APPLICATION #274 – RESPONSES TO QUESTIONS

EXHIBIT 9

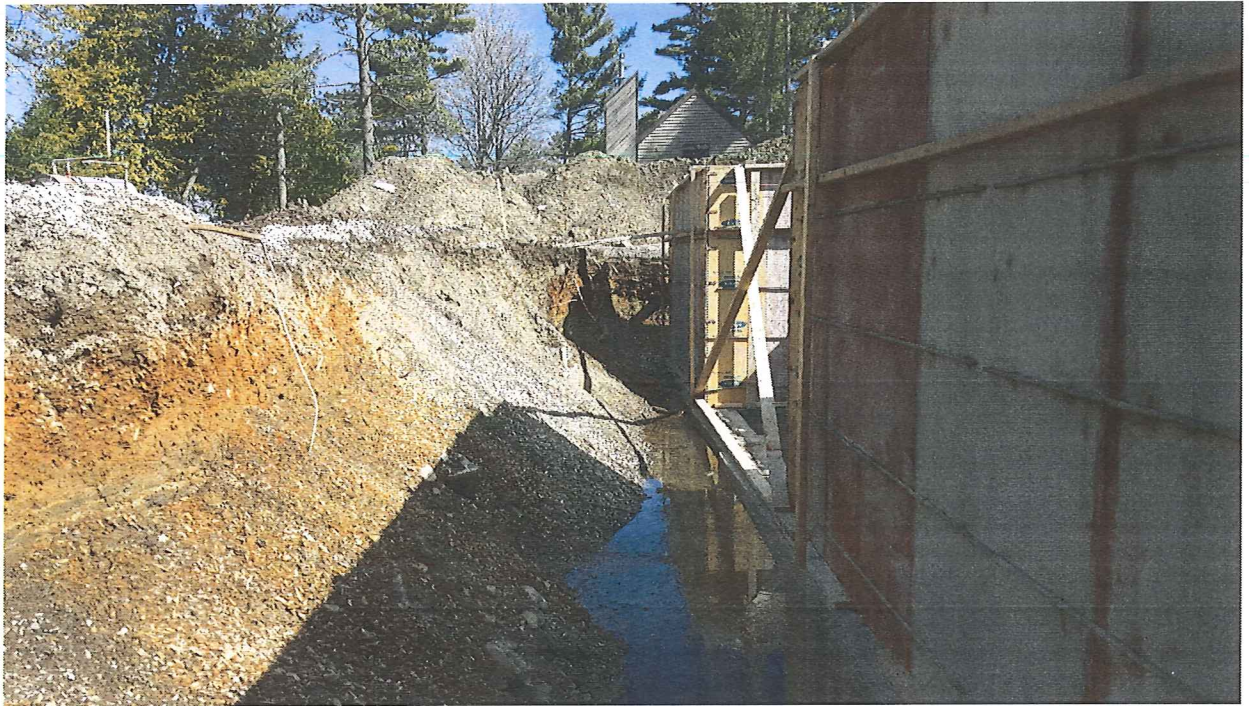
2. Please add to the site plan or a different sheet the previous footprint of the habitable structures.

Please see attached site plan showing new and existing structures, with measurements (Exhibit 7). The previous habitable structure was 6' closer to the lake. Even though demolition has commenced, you can still see remnants of the existing foundation walls in our new cellar hole. (Exhibits 8 & 9). The raised structures and removed asphalt, in comparison to the new structure and replaced asphalt will result in a net loss of impervious area. (i.e., we are building less than what was originally on site.) You can see from the current site photos the location of the existing concrete pad gravel (Exhibit 10) and the existing asphalt that is being removed which led to the former garage (Exhibit 13) . The garage is now going to be located in a closer position to the entrance of the property in distance from the road, and without having to traverse across the front of the home. These changes made a significant reduction to the amount of impervious surfaces.
